Neil A. Sharkey
Vice President for Research
The Pennsylvania State University
304 Old Main
University Park, PA 16802-1504

Re: License Amendment Request, License R-2, Docket 50-005

Attached please find a request for the modification of the Penn State Breazeale Reactor operating license, # R-2. This amendment will allow for the improvement of the reactor ventilation systems via the addition of a Reactor Bay Heating Ventilation and Exhaust System (RBHVES), which is intended to improve the economy of heating and cooling the reactor bay. The existing facility exhaust system (FES) will remain and will operate as a component of the RBHVES. A license amendment is necessary to support several revisions to the Technical Specifications which will be necessary in order to allow the RBHVES to be used as the primary exhaust system. In addition to revising the Technical Specifications, updated versions of Chapter 6 - Engineered Safety Features and Chapter 9 - Auxiliary Systems of the Safety Analysis Report have been prepared and are included as part of this LAR.

Evaluation of the Proposed Change

Figure 6-1 Reactor Bay HVAC and Emergency Exhaust Systems

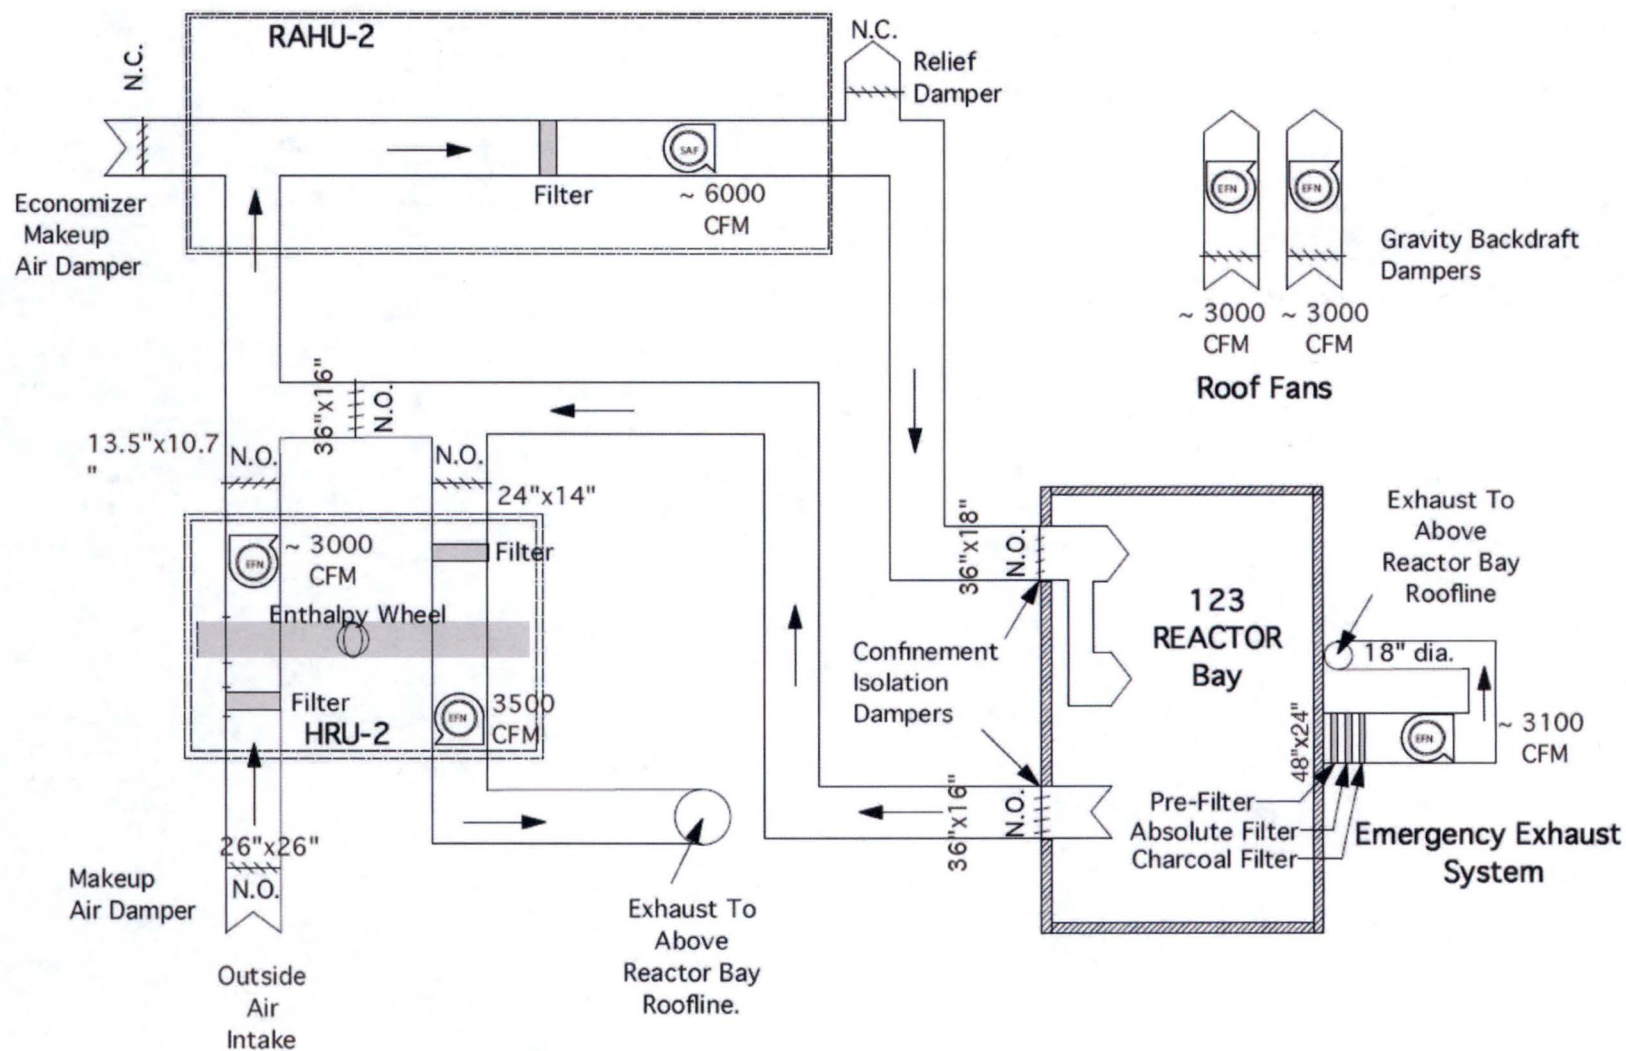
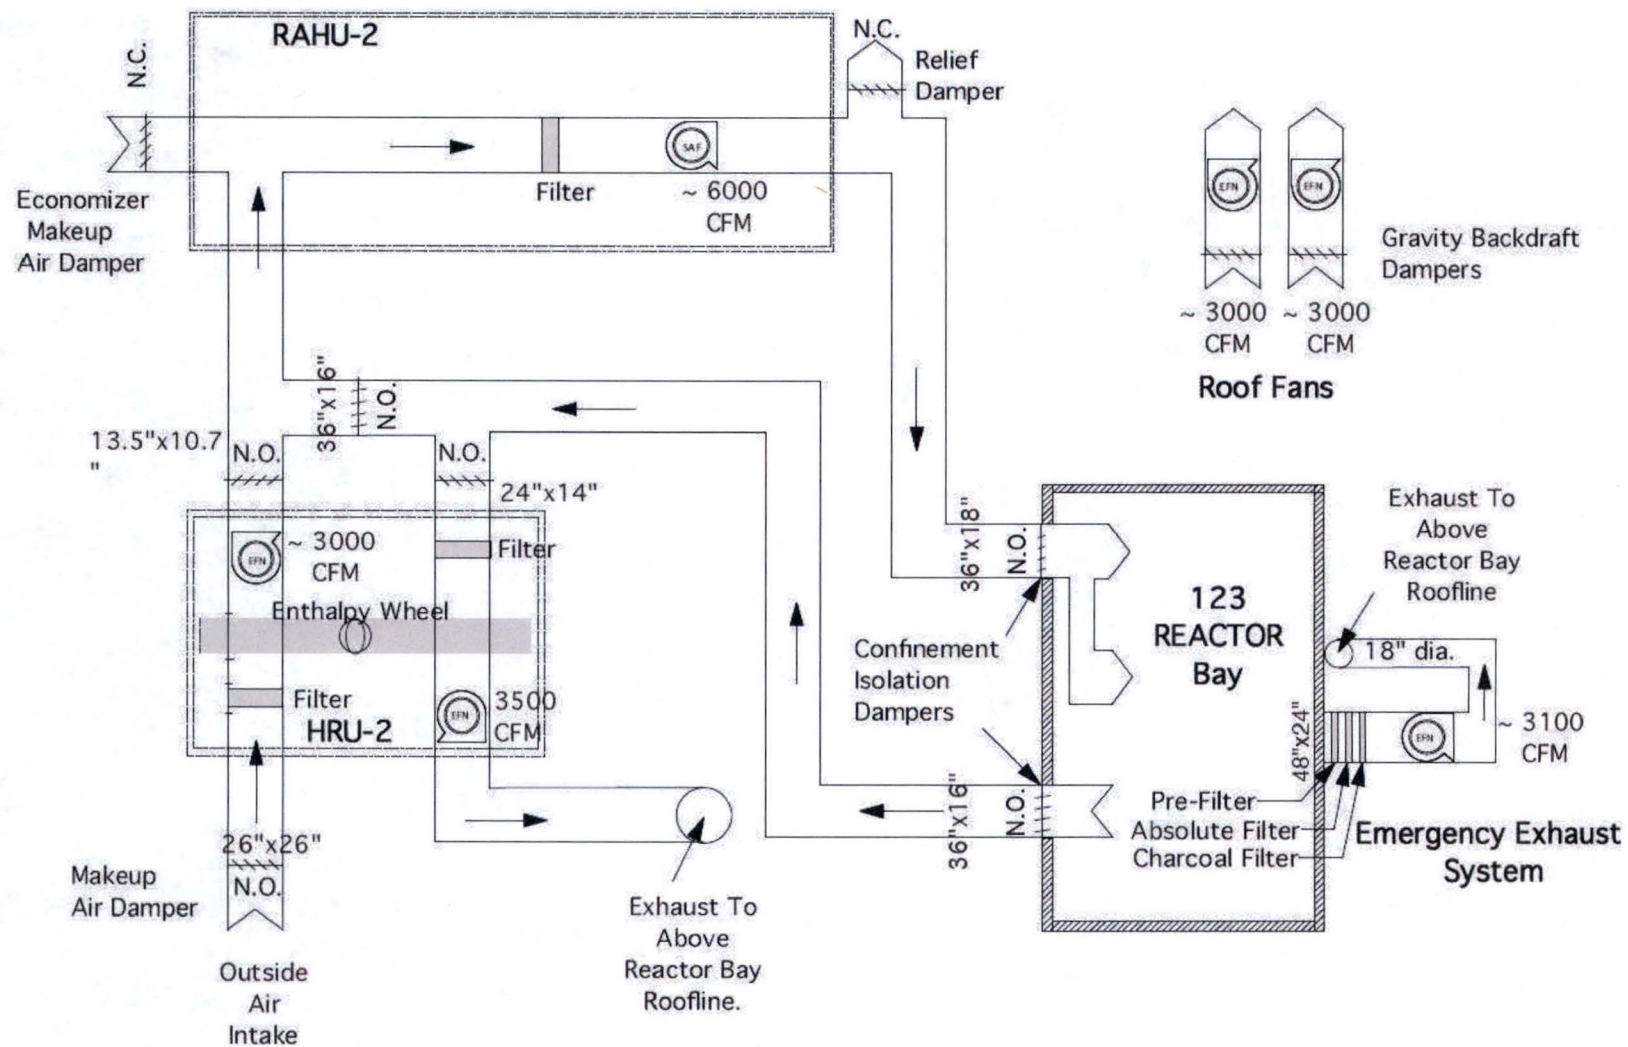
The ~70,000 feet³ (1900 m³) minimum volume reactor bay is maintained at a negative pressure with respect to the remainder of the building by one or more of two-four separate exhaust fanssystems (see Figure 6-1). Depending on operational configuration, fFresh air to the room reactor bay is supplied by leaks around doors, and penetrations and by the supply air fanete. Normal heating, cooling, ventilation, and negative pressure of the reactor bay is maintained is by the reactor bay RBHVESfacility exhaust system (FES). An filtered emergency exhaust system (EES) is also available.

When the evacuation alarm system is activated, any operating RBHVES fans are shutdown, associated confinement isolation dampers shut, and the EES system starts. The EES creates sufficient negative pressure in the reactor bay so that any movement of radioactive material from the bay would be through the system filters. Air enters the EES through a screened opening in the east wall of the reactor bay about ~14 feet (~4.27 m) above the bay floor (see Figure 6-2 EES System). The air then passes through a pre-filter, absolute filter, and carbon filter that are mounted in a housing on the roof of the east extension of the reactor bay. The three-horsepower exhaust fan (~31400 feet³/min or ~9.1 x 10⁴ l/min with motor operated damper completely open and clean filters) is also mounted there. Flow can be reduced through the system by adjusting the motorized damper (located at the fan suction) open position. Filtered air exhausts into an 18 inch (46 cm) diameter PVC pipe and stack. The stack travels up the east outside wall of the reactor building and exhausts at a point above the reactor bay roof (~3-24 feet or ~7.3 m above ground-reactor bay floor level). [MAT1][MAT2]

The ~70,000 feet³ (1900 m³) minimum volume reactor bay is maintained at a negative pressure with respect to the remainder of the building by one or more of four separate exhaust fans (**see Figure 6-1**). Depending on operational configuration, fresh air to the reactor bay is supplied by leaks around doors and penetrations and by the supply air fan. Normal heating, cooling, ventilation, and negative pressure of the reactor bay is maintained by the RBHVES. A filtered emergency exhaust system (EES) is also available.

When the evacuation alarm system is activated, any operating RBHVES fans are shutdown, associated confinement isolation dampers shut, and the EES system starts. The EES creates sufficient negative pressure in the reactor bay so that any movement of radioactive material from the bay would be through the system filters. Air enters the EES through a screened opening in the east wall of the reactor bay about ~14 feet (~4 m) above the bay floor (see Figure 6-2 EES System). The air then passes through a pre-filter, absolute filter, and carbon filter that are mounted in a housing on the roof of the east extension of the reactor bay. The exhaust fan (~3100 feet³/min or ~9.1 x 10⁴ l/min with motor operated damper completely open and clean filters) is also mounted there. Flow can be reduced through the system by adjusting the motorized damper (located at the fan suction) open position. Filtered air exhausts into an 18 inch (46 cm) diameter PVC pipe and stack. The stack travels up the east outside wall of the reactor building and exhausts at a point above the reactor bay roof (~34 feet above reactor bay floor level).
